AMENDMENT OF SOLICITATION/MODIFICATION OF CONTRACT

2. Amendment/Modification Number
Three (3)

5. Solicitation Caption
DDOT Centralized Dynamic Message Signs

Questions and Answers

LED Full-Matrix DMS Type I

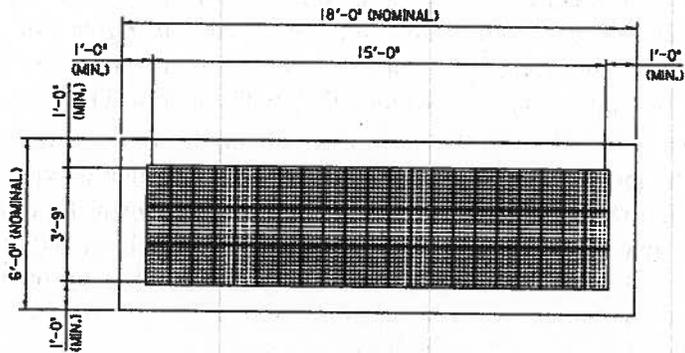
1. **DMS Type – The DMS to be supplied under this contract shall be of the following types:**
 - a. **Type I** shall be LED Full-Matrix DMS (27 x 145 pixels, 66 mm pitch), 30-degree viewing cone, capable of displaying at least 3 lines, each with 21 18-inch characters per line, flashing beacons where applicable, and walk-in housing for installation on major freeways and arterials. [ADDENDUM NO. 3 REVISED] Nominal dimensions for cabinet shall be 10ft H x 34ft W x 4ft D and 4,500 lbs.

DMS CABINET LAYOUT DIAGRAMS

[ADDENDUM NO. 3 ADDED]

OVER-HEAD SIGN STRUCTURE
FULL-SPAN SIGN SUPPORT
DMS 6007

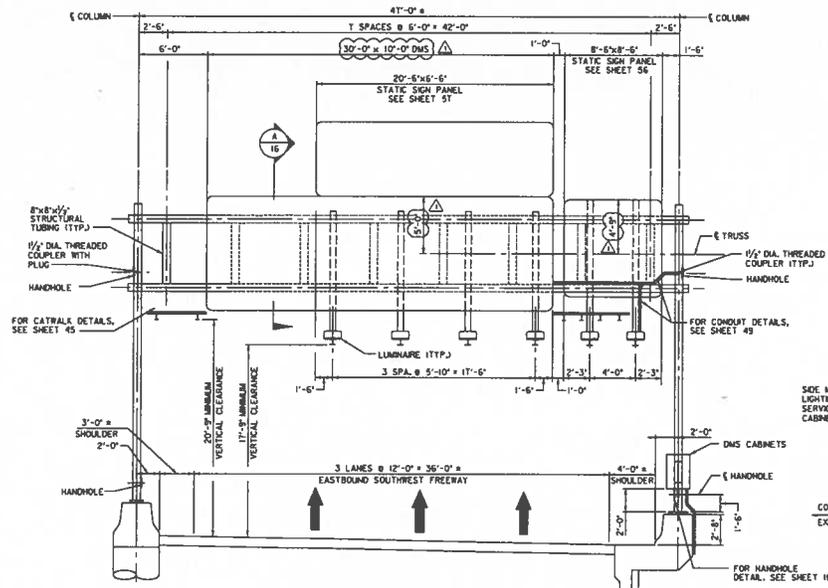
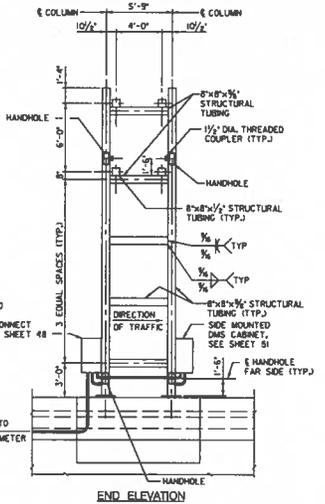
NO.	DESCRIPTION	DATE	BY
1	REVISED DMS CABINET DIMENSION	DEN 07/28/12	JAC

OVERHEAD SIGN STRUCTURE
FULL-SPAN SIGN SUPPORT
DMS 8025

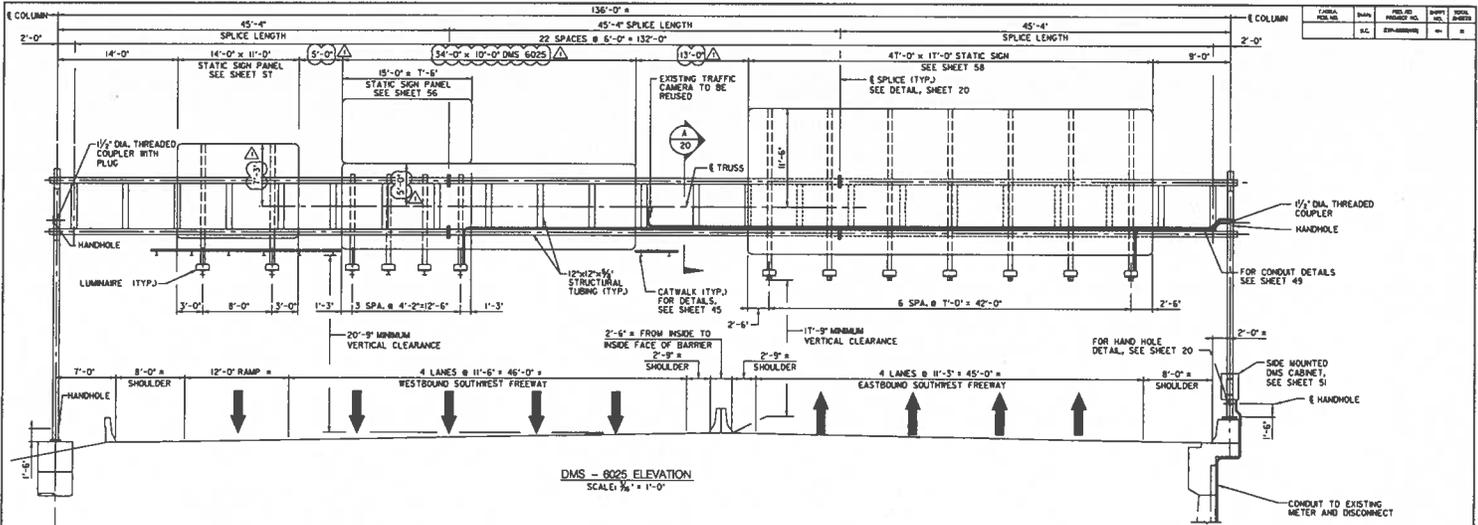
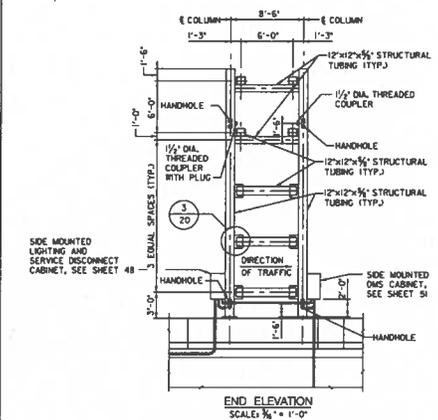
NO.	DESCRIPTION	DATE
1	REVISED DMS CABINET DIMENSION	9/28/10

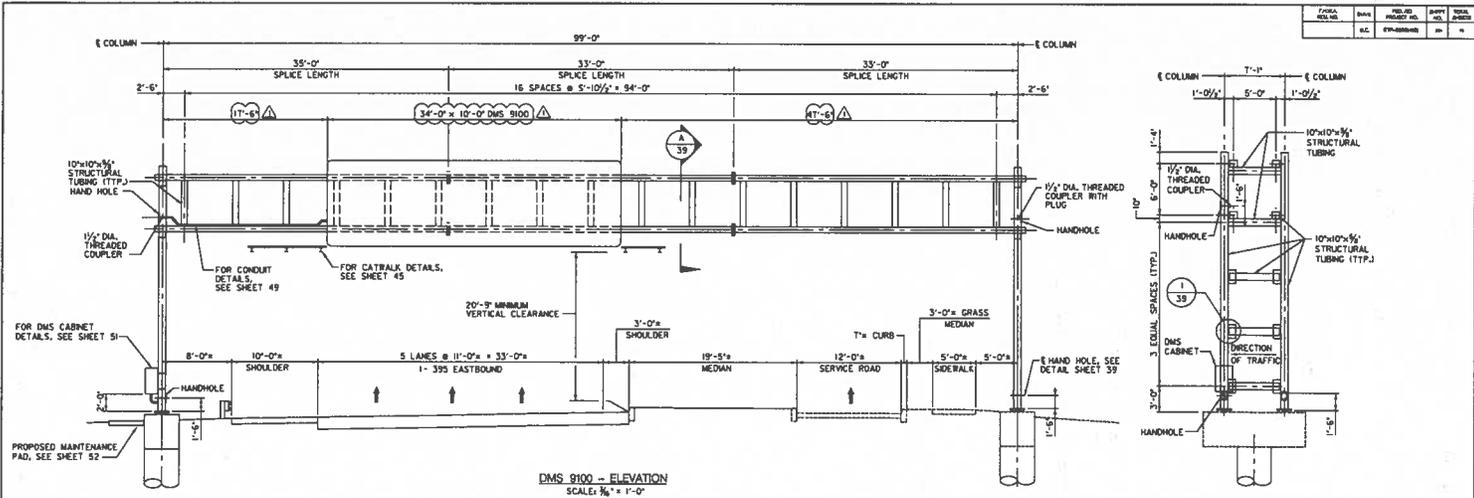
NO.	DESCRIPTION	DATE
1	REVISED DMS CABINET DIMENSION	02/28/02
